PRSC20250828

CITY OF PUYALLUP
PUBLIC WORKS
WATER DIVISION

LONG DURATION TEMPORARY WATER SERVICES FOR WSDOT

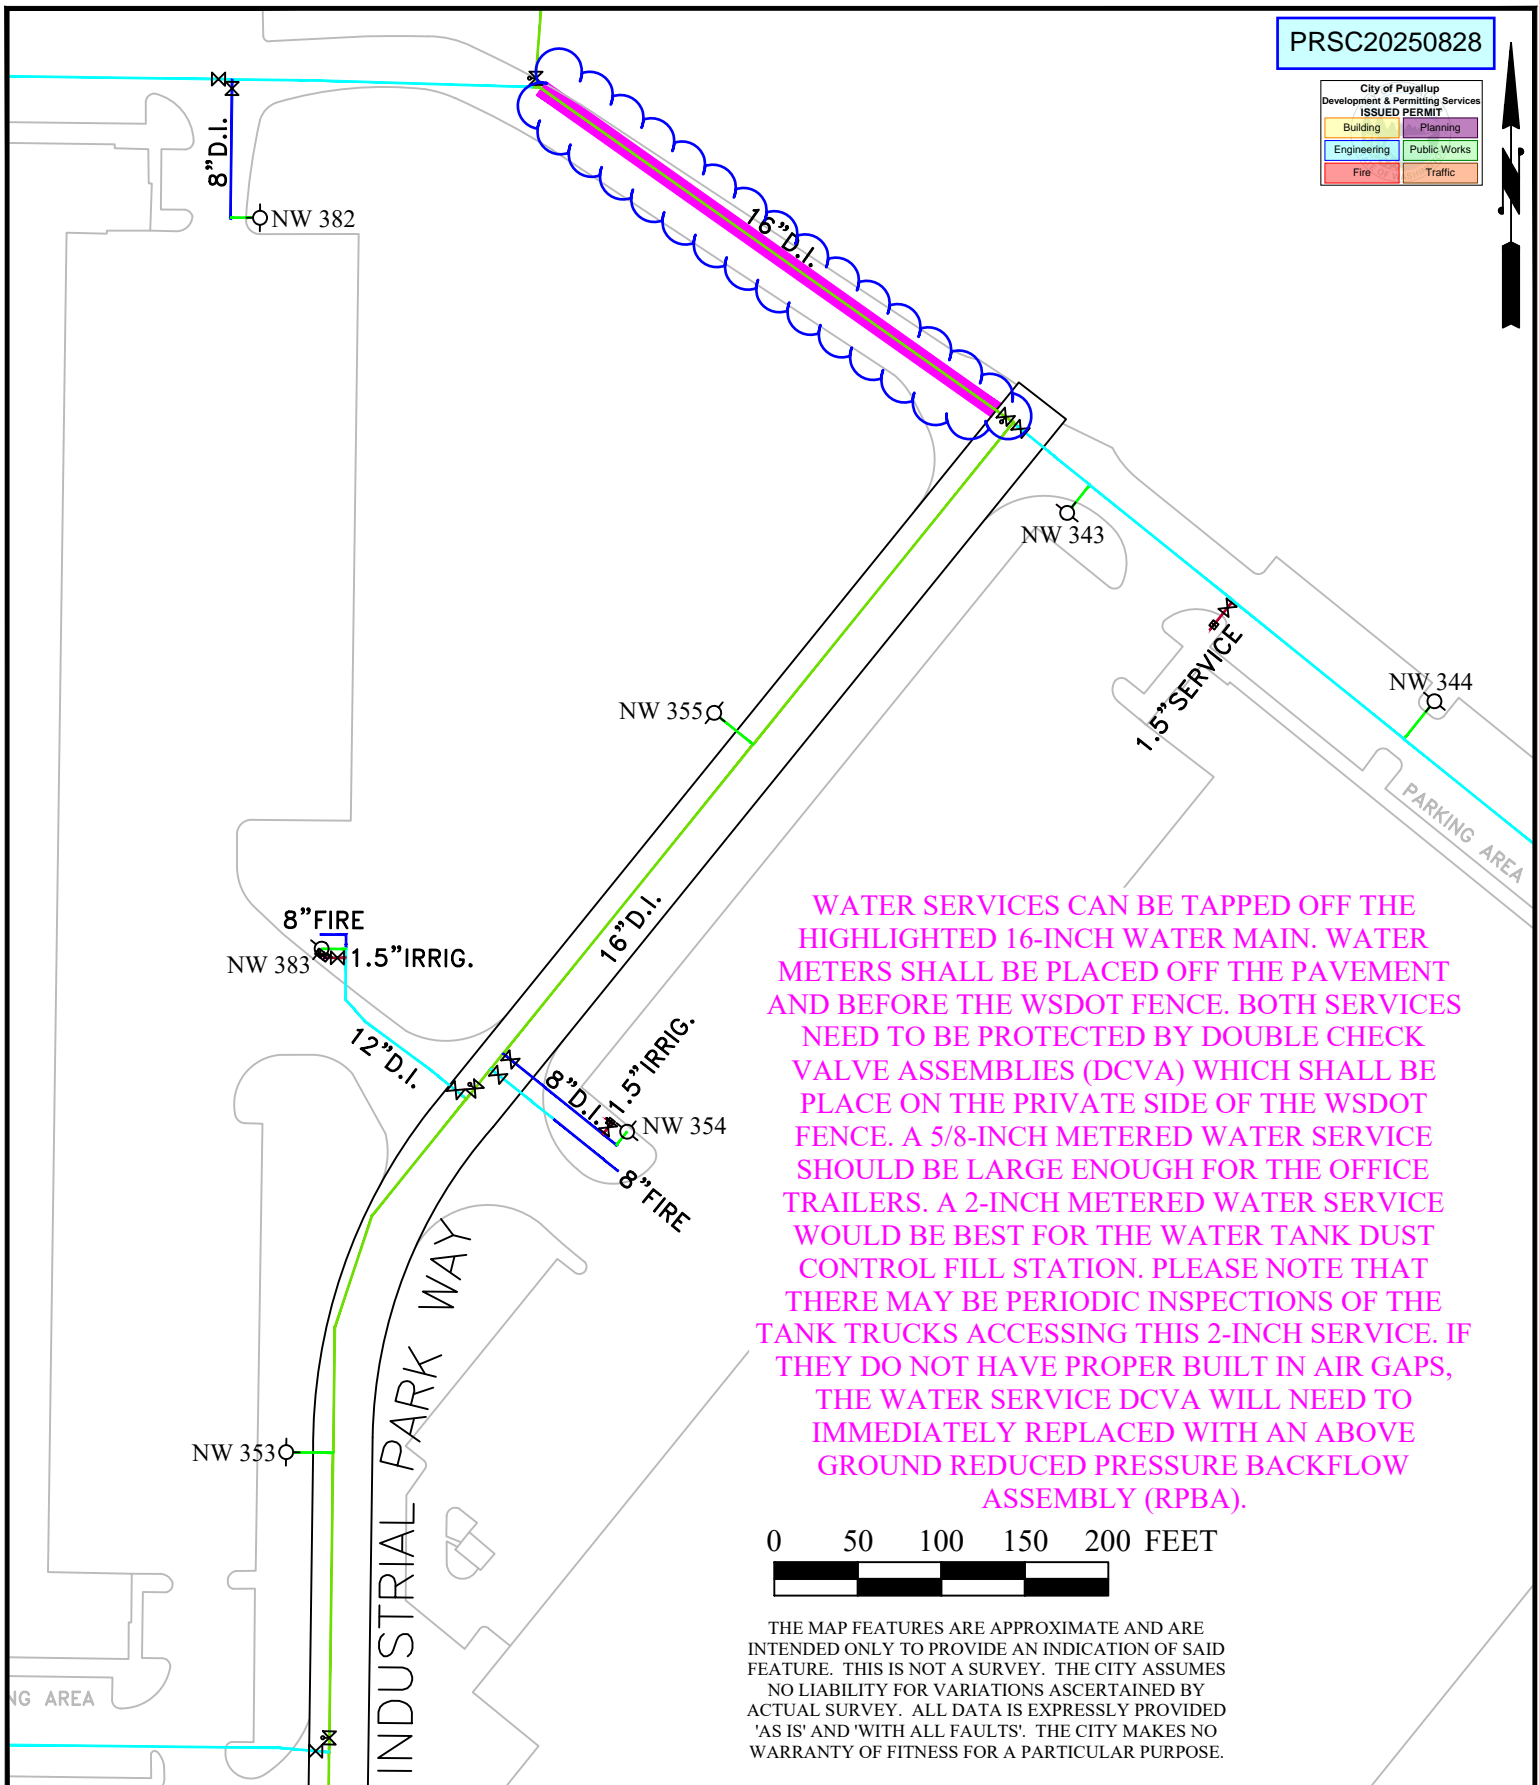
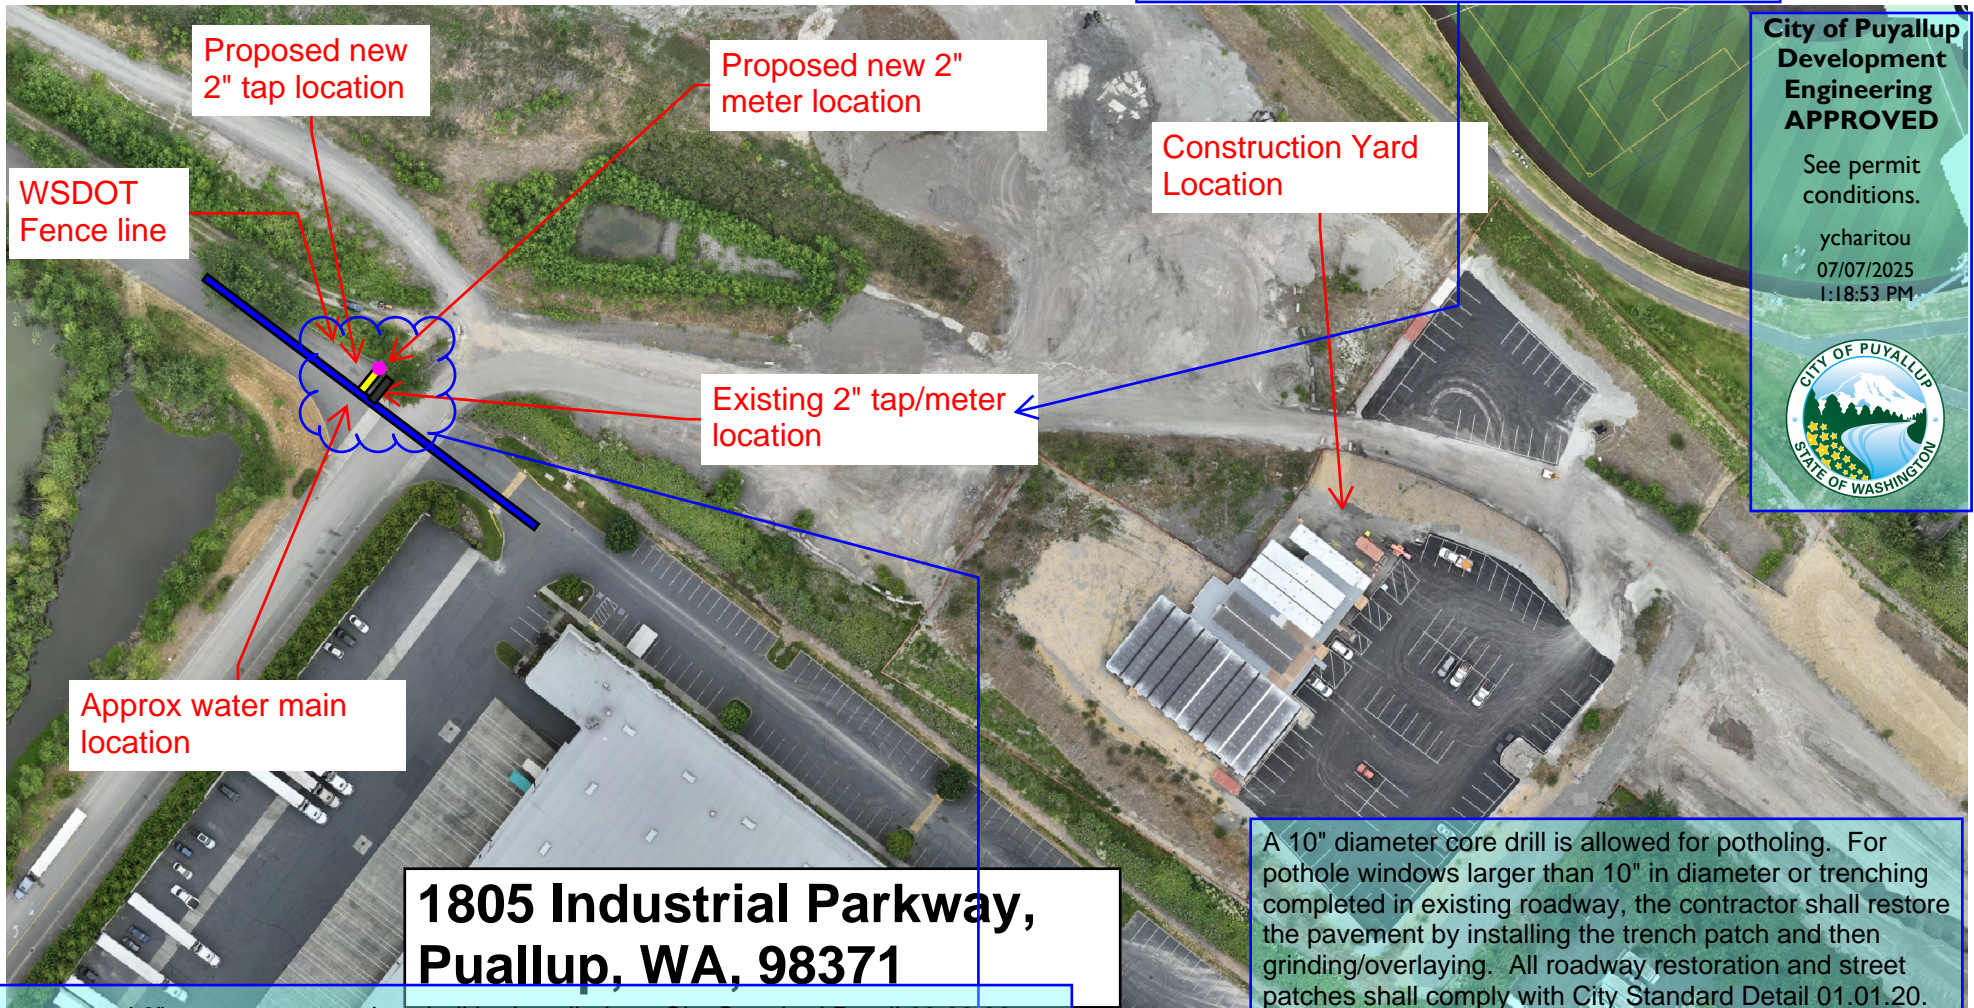
Prior to tapping the new water services, the contractor, in the presence of the City Inspector or City Water Department, shall determine the location of the proposed tap and the tap location of the future 8" water service to serve the future WSDOT weigh station. Moreover, the proposed 2" service shall be tapped at least 2 feet from the existing, adjacent 2" tap installed under permit PRSC20250218.

A 10" diameter core drill is allowed for potholing. For pothole windows larger than 10" in diameter or trenching completed in existing roadway, the contractor shall restore the pavement by installing the trench patch and then grinding/overlaying. All roadway restoration and street patches shall comply with City Standard Detail 01.01.20.

The proposed 2" meter water service shall be installed per City Standard Detail 03.03.02.

The water meter box shall be installed on the City side of the WSDOT fence and within the recorded utility easement. The water service shall be protected with a DCVA backflow protection device installed per City Standard Detail 03.04.01 and located on the WSDOT side of the fence. If any trucks utilizing the 2-inch water service do not have built-in air gaps, the backflow protection device shall be immediately upgraded to an above-ground reduced pressure backflow assembly (RPBA). The City may periodically inspect tank trucks utilizing the 2-inch water service for compliance with the City's cross-connection program.

require the contractor to hire a licensed surveyor to determine the location of the water services in relation to the property lines and easement area.

All work proposed in the recorded water easement (AFN 200901270741) shall comply with the conditions of said easement. The City of Puyallup does not authorize or permit utility work outside the water utility easement. The permit holder shall be responsible to obtain the necessary permissions from property owners prior to starting work.
